**6-G-21-HZ**  
**APPLICATION FOR CERTIFICATE OF APPROPRIATENESS**

**204 E. Scott Ave. 37917**  
**Old North Knoxville H**

Original Print Date: 6/8/2021  
 Knoxville/Knox County Planning -- Historic Zoning Commission

# KLOSS RESIDENCE - 204 E. SCOTT AVE.

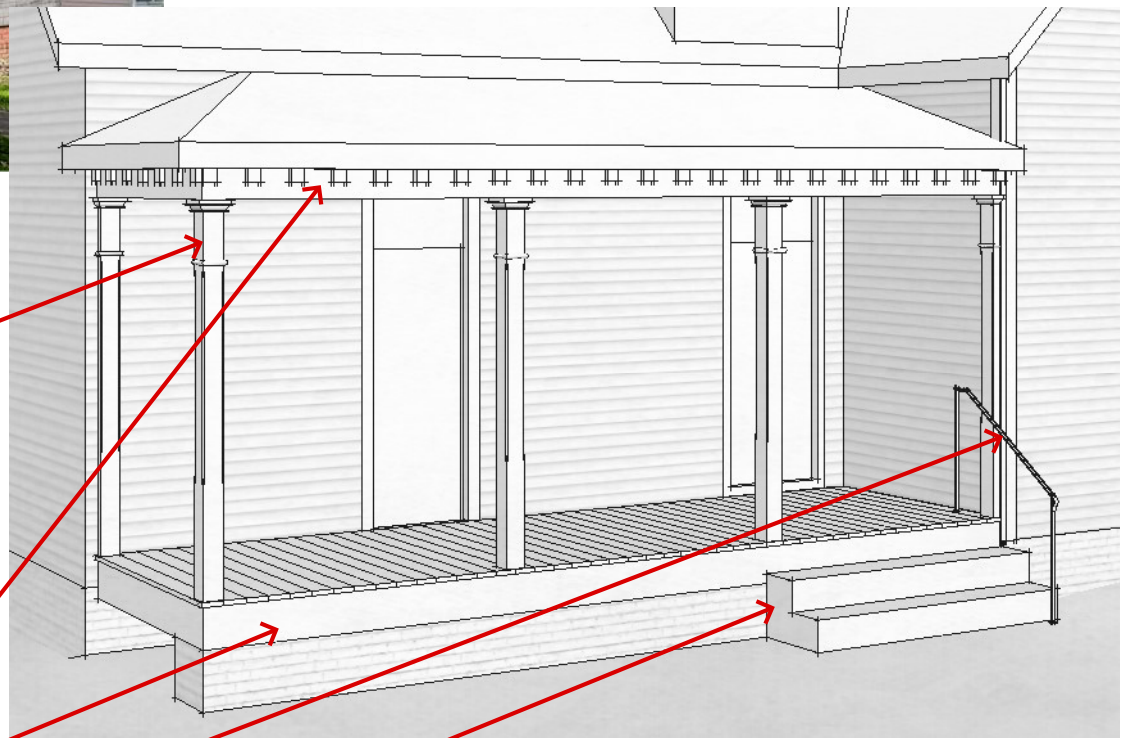
4. The front porch supports are temporary and appropriate for removal. Construction of the new porch supports draws on evidence from paint ghosts on the porch beam, and the two remaining half columns on the left corner and right corner of the porch. Replication of the original column design and repair to the unique dentiled cornice will restore the porch to its original state. The small wrought iron handrail will have a minimal impact on the overall house.

Repair masonry chimney between living and dining room

Remove asphalt siding from exterior, repair original wood siding underneath

Restore existing windows to working condition. Install exterior wood storm windows (specification attached).

New roof (asphalt shingles or other material TBD. specification can be provided to HZC)

Replace temporary porch supports with painted wood columns to match original, placed in original locations (evident from missing paint on porch beam).

New gutters, typ. (profile can be provided to HZC staff for approval prior to installation; not pictured in rendering)

Original porch beam and dentil molding to remain, repair as needed

Replace skirtboard with new painted, wood skirtboard to match original in size and profile

New wrought iron handrail at steps

Concrete steps to remain

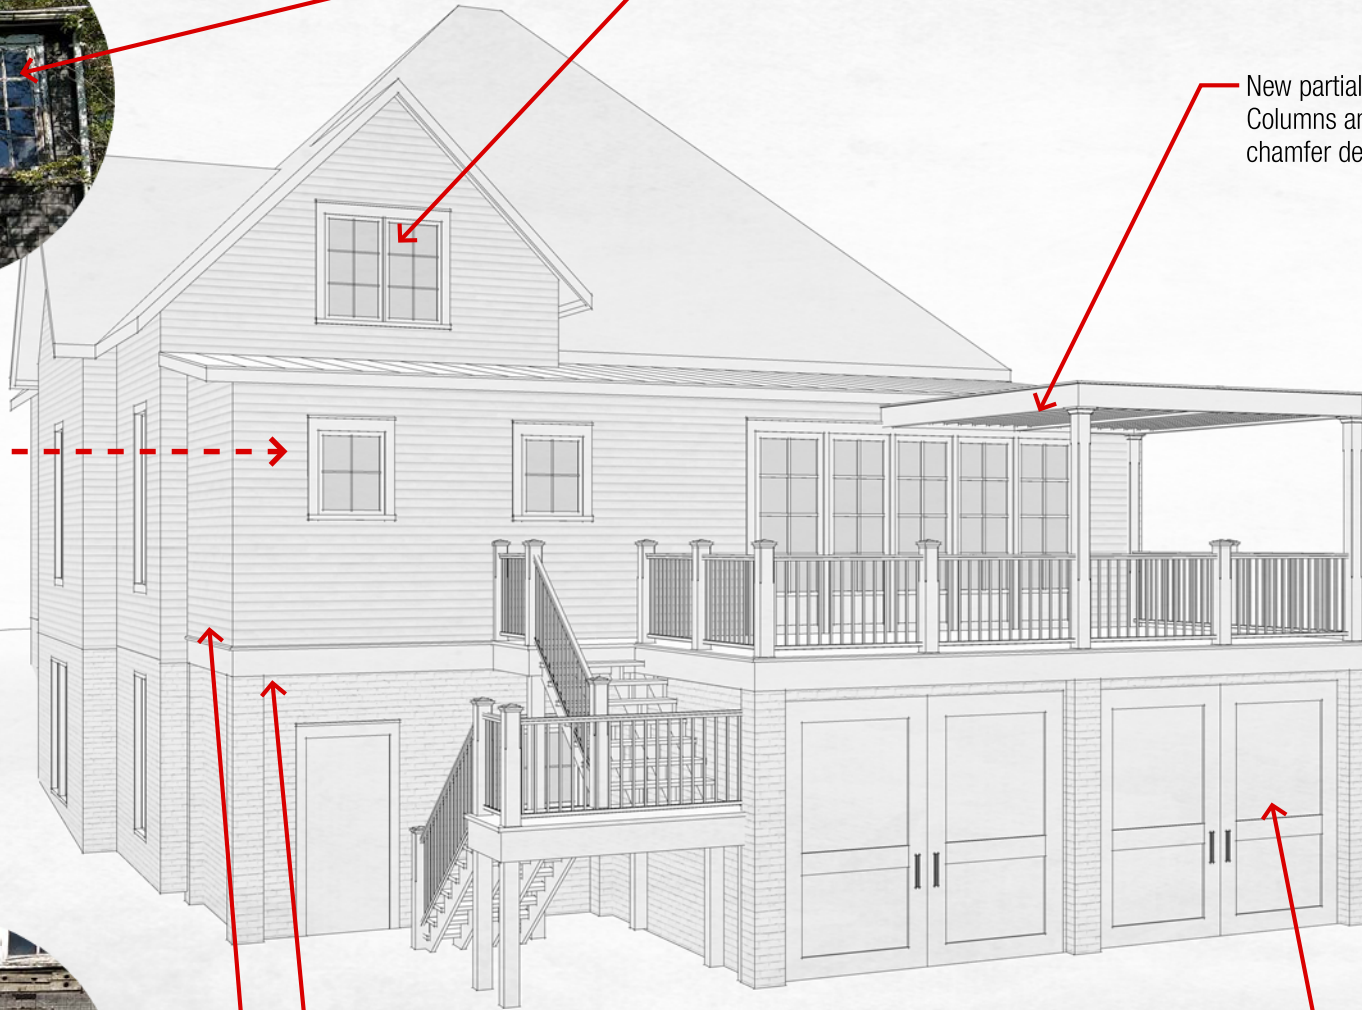
5. On the left side, removal of the secondary door is appropriate as it was most likely a later modification, is not a character-defining feature of the house, and does not access a porch or deck.

6. On the side gable fields, increasing the existing window openings by 6" in height is a minimal change. The fenestrations are existing and an additional 6" in height will not make the new windows disproportionate to the house. The proposed new casement windows will be built to match similar casements on the house (drawing on original windows found in the attic). Final specifications should be submitted to staff for approval.

7. The chimney is minimal in size, not visible from Scott Ave. or McMillan Street, and does not contribute to the overall character of the house. In this instance, removal of the rear chimney is appropriate.

8. Reconstruction of the rear addition with a footprint, materials, and roof pitch to match the existing is appropriate. The aim to retain and reuse as many original features (such as windows) as possible is ideal. If rear elevation windows cannot be salvaged, specifications should be submitted to staff for approval.

Remove "floating door." Cover opening with siding to match original.

Remove this basement door, replace with brick to match foundation brick.

Increase head height on these two, side-facing attic windows (north and south) by 6" to allow them to qualify as bedroom egress windows. Trim on exterior to match existing. New casement windows to be built to match original frame style (parts of these original windows were found in attic).

Remove this kitchen chimney. This is the only angle of the house from which it can be seen.

This old addition on the rear is water-damaged beyond repair. It will be removed, saving any windows or other in-tact historic elements that can be reused. A new addition will be built in the old footprint; see next page.

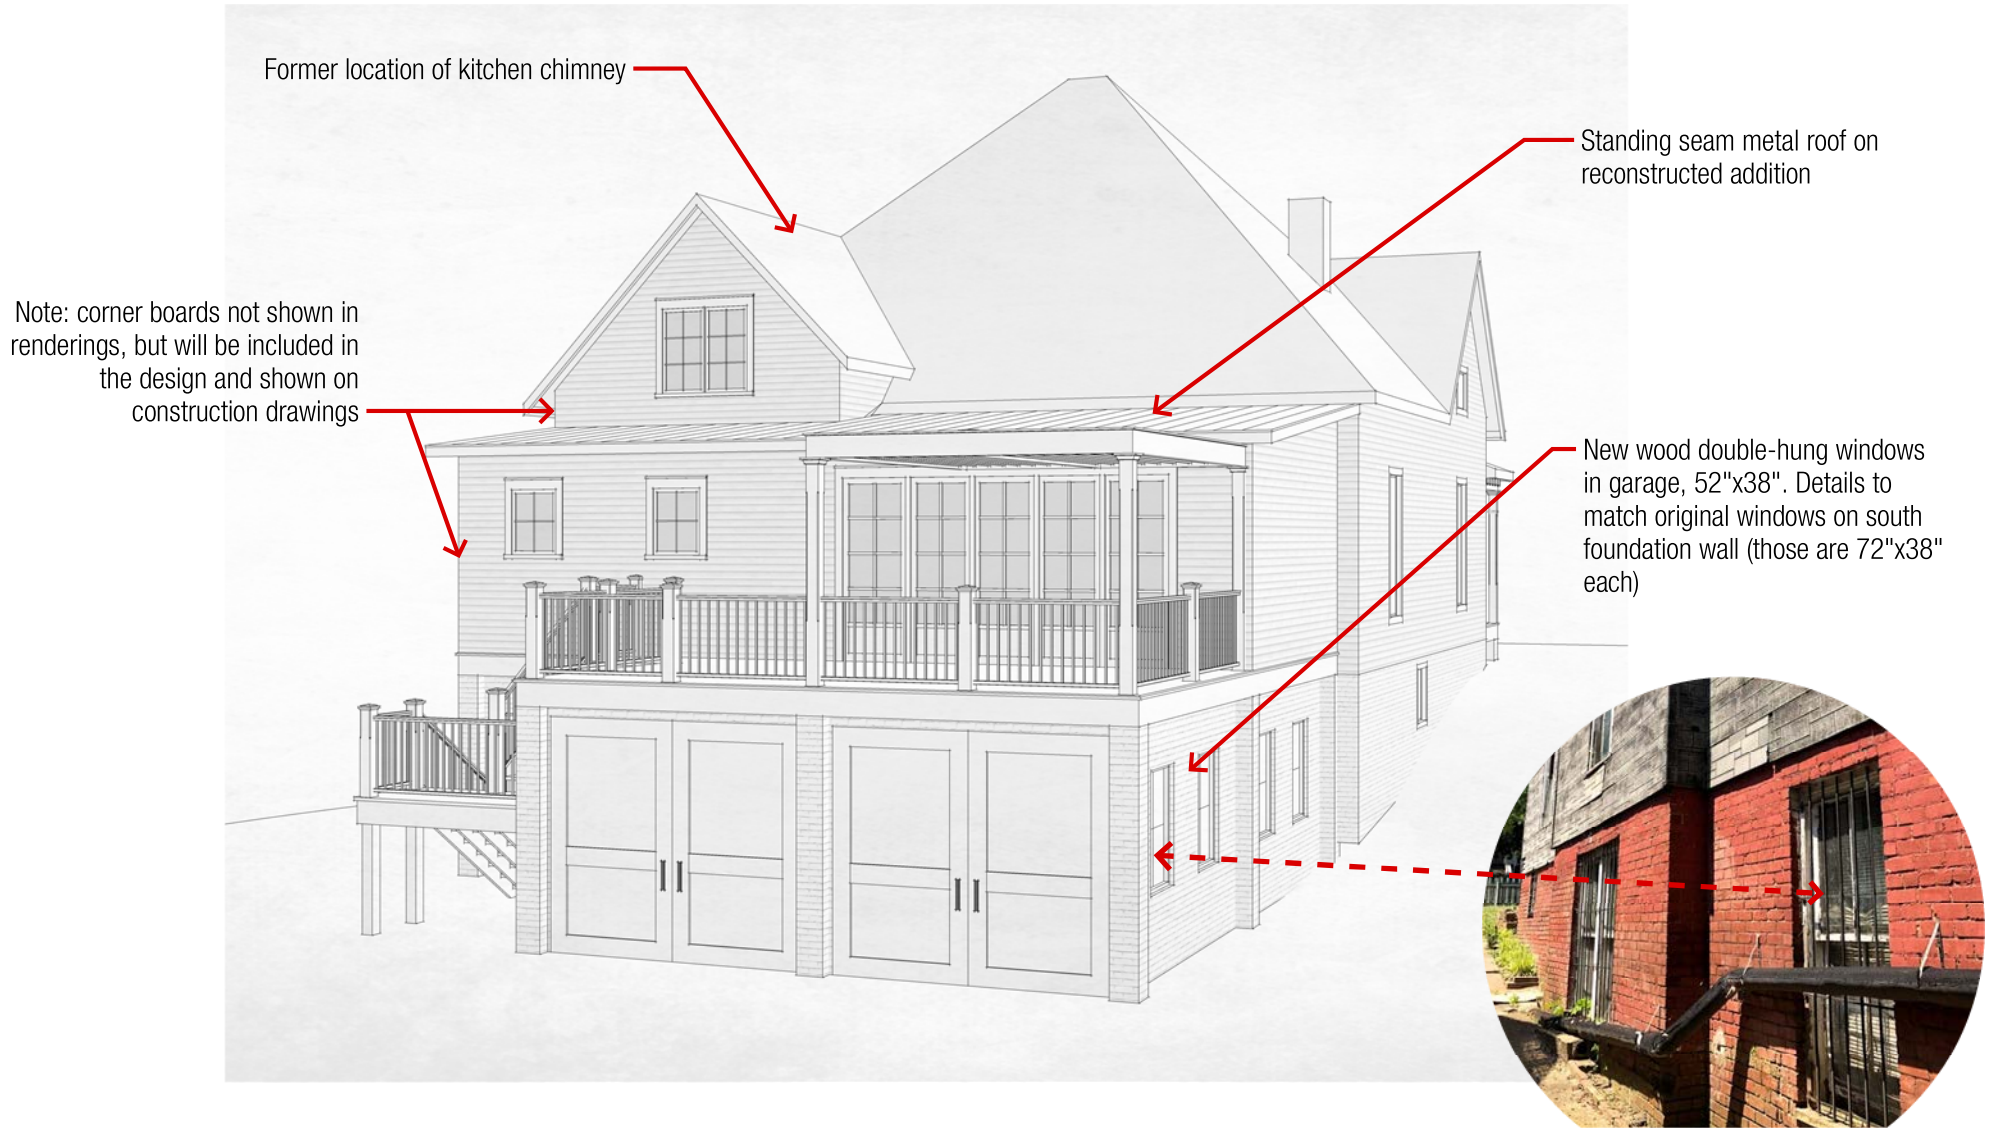
9. The rear addition is proposed for the rear of the house, with the lower-level garage to connect to a basement elevation with no major character-defining features. The garage and deck addition are proportionate to the historic house and use compatible materials. The addition will be differentiated from the original house by a small offset; the modest flat-roof covering the deck will also serve to differentiate the addition. Final selection for garage doors should be submitted to staff for approval.

10. The new wood double casement window proposed for the rear gable field is proportionate to the gable field, with a design that matches original casement windows on the house. The new window would not be visible from the street.

New wood double casement window. Trim, frame, and muntin profiles to match original windows on house. Photo shows original windows to be used as basis of design.

New partially-covered deck above garage. Columns and railing posts (6x6 size) to have chamfer detail similar to front porch columns.

Carriage-style garage doors. See attached specification.

Water table trim band divides lap siding and brick foundation; continues around deck.

New, reconstructed addition. Main level to have lap siding to match original, lower level to have brick cladding to match house foundation.

Staff recommends approval of the work as proposed, with the condition that 1) new roofing material and final garage door specifications be submitted to staff for approval; and, 2) if any windows require replacement, new windows should match originals in design, size, and material, with specifications submitted to staff for approval.
